HISTORIC AND DESIGN REVIEW COMMISSION

December 07, 2022

HDRC CASE NO: 2022-561
ADDRESS: 224 E CAROLINA ST
LEGAL DESCRIPTION: NCB 2956 BLK LOT B
ZONING: RM-4, H
CITY COUNCIL DIST.: 1
DISTRICT: Lavaca Historic District
APPLICANT: Melissa Stendahl/STENDAHL MELISSA & BENJAMIN
OWNER: Melissa Stendahl/STENDAHL MELISSA & BENJAMIN
TYPE OF WORK: Fenestration modifications and Historic Tax Certification
APPLICATION RECEIVED: November 11, 2022
60-DAY REVIEW: Not applicable due to City Council Emergency Orders
CASE MANAGER: Rachel Rettaliata

Rear Configuration - support for exemption from further changes

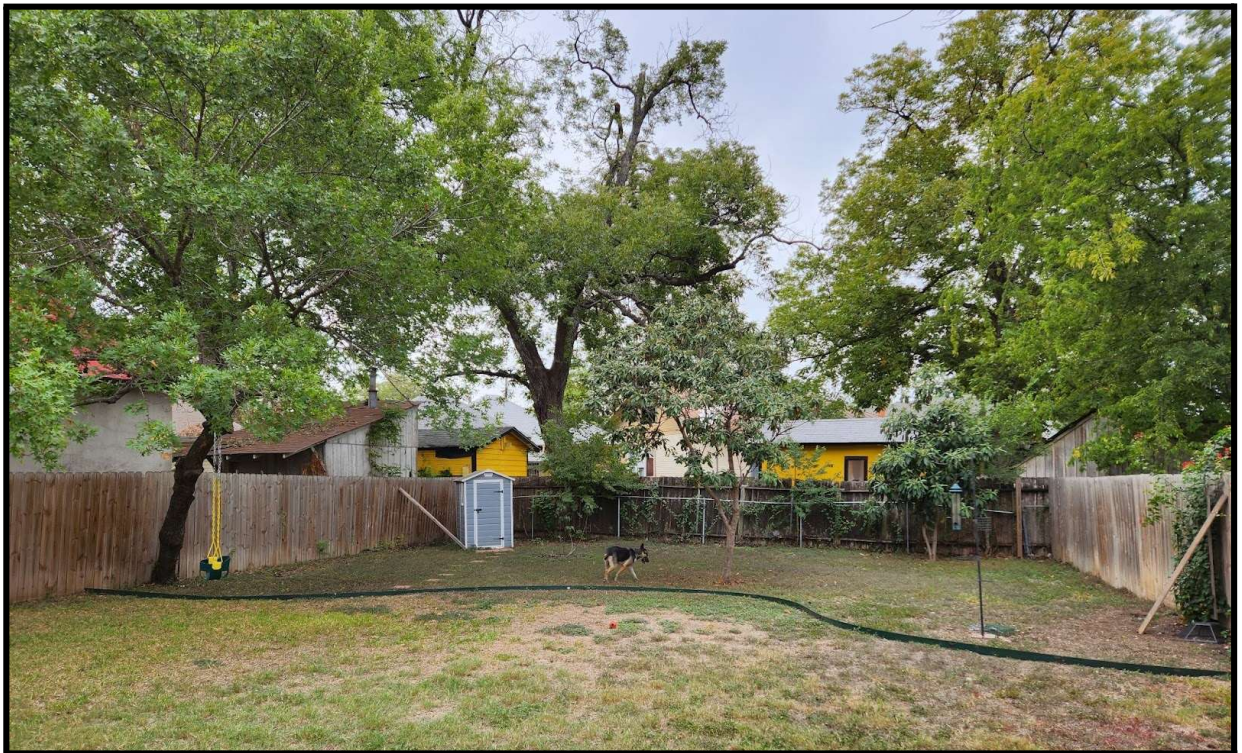
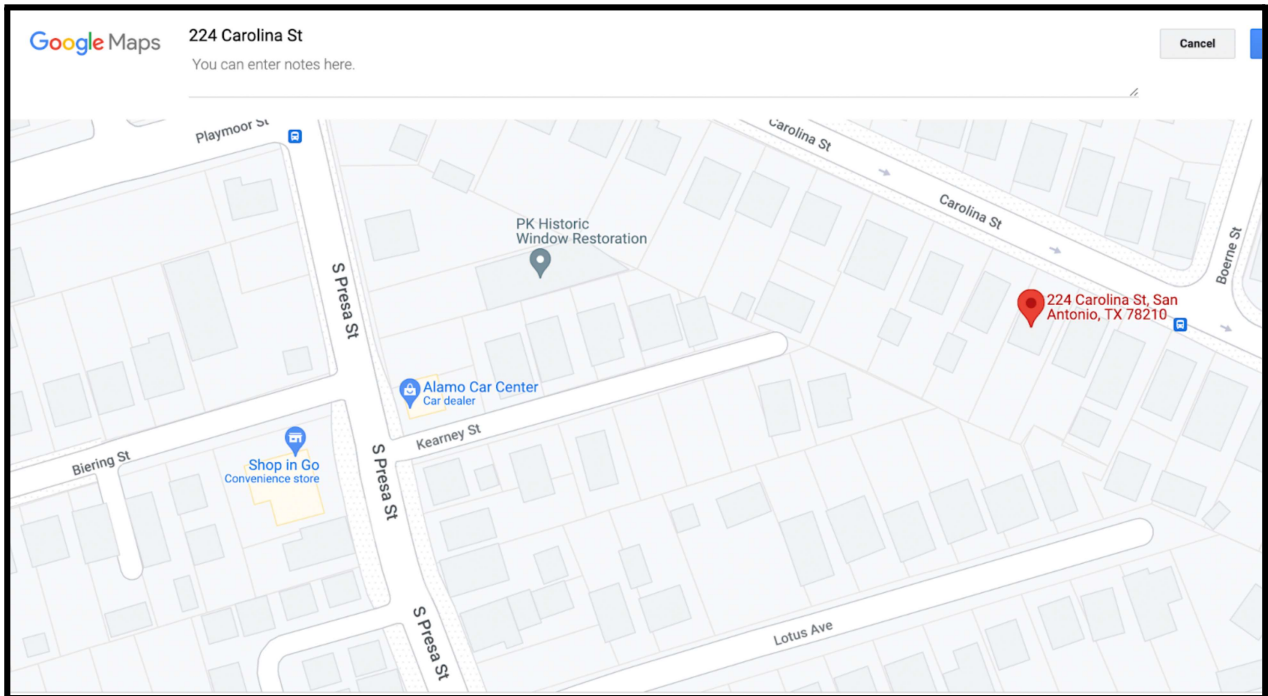
The interior (second floor) does not support the addition of windows. The master bathroom, master closet, and another bedroom closet fully occupy this wall. Additionally, the rear of the house is not visible from the street behind it. Photo evidence, in order, includes:

- Rear of house
- Master bath
- Master closet
- Bedroom closet
- View of backyard from rear of house
- View from directly behind our house on the street behind us
- Second view from the rear street
- Third view from the rear street
- Google map showing location of home in relation to neighboring streets and the impossibility of a sight line to the rear of the house from a neighboring street

PROPOSED ELEVATIONS
224 CAROLINA ST
SAN ANTONIO, TX 78210

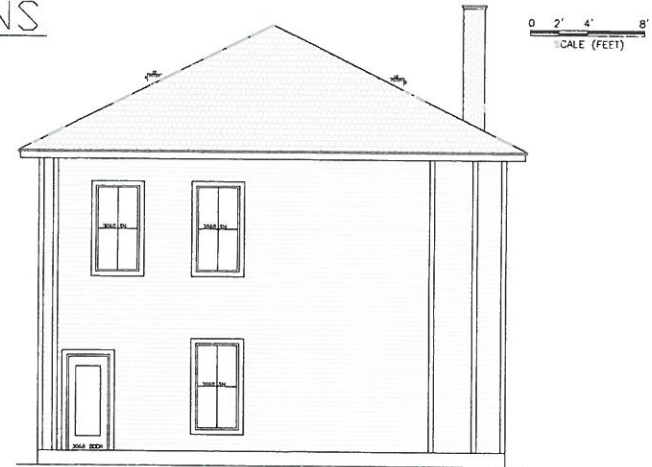
- d. FENESTRATION MODIFICATIONS – The applicant has proposed to remove three (3) window openings on the rear elevation and two (2) window openings on the west elevation of the rear addition and enclose the openings with siding. The applicant has proposed to install a fixed square window on the east corner of the second story of the rear elevation, one (1) one-over-one window on the east end of the first story of the rear elevation, one (1) one-over-one window on the first story of the east elevation, one (1) set of French doors on the rear elevation, and one (1) half-lite door on the rear elevation. Guideline 6.A.i for Exterior Maintenance and Alterations states that existing window and door openings should be preserved. Avoid enlarging or diminishing to fit stock sizes or air conditioning units. Avoid filling in historic door or window openings. Staff finds that the proposed fenestration pattern results in a loss of four (4) one-over-one windows of traditional proportions on the rear addition. Staff finds that the previously existing window and door openings should be preserved and that the applicant should return the fenestration pattern to its previous configuration or should submit plans for the installation of appropriate fenestration on the rear addition. The windows should feature an inset of two (2) inches within facades and should feature profiles that are found historically within the immediate vicinity. Meeting rails must be no taller than 1.25” and stiles no wider than 2.25”. White manufacturer’s color is not allowed, and color selection must be presented to staff. There should be a minimum of two inches in depth between the front face of the window trim and the front face of the top window sash. This must be accomplished by recessing the window sufficiently within the opening or with the installation of additional window trim to add thickness. Window trim must feature traditional dimensions and architecturally appropriate sill detail. Window track components must be painted to match the window trim or concealed by a wood window screen set within the opening.

Staff does not recommend approval of the fenestration modifications or Historic Tax Certification based on findings a through e. Staff finds that the applicant should restore the fenestration pattern on the rear addition to its previous condition or should submit plans for the installation of appropriate fenestration on the rear addition.
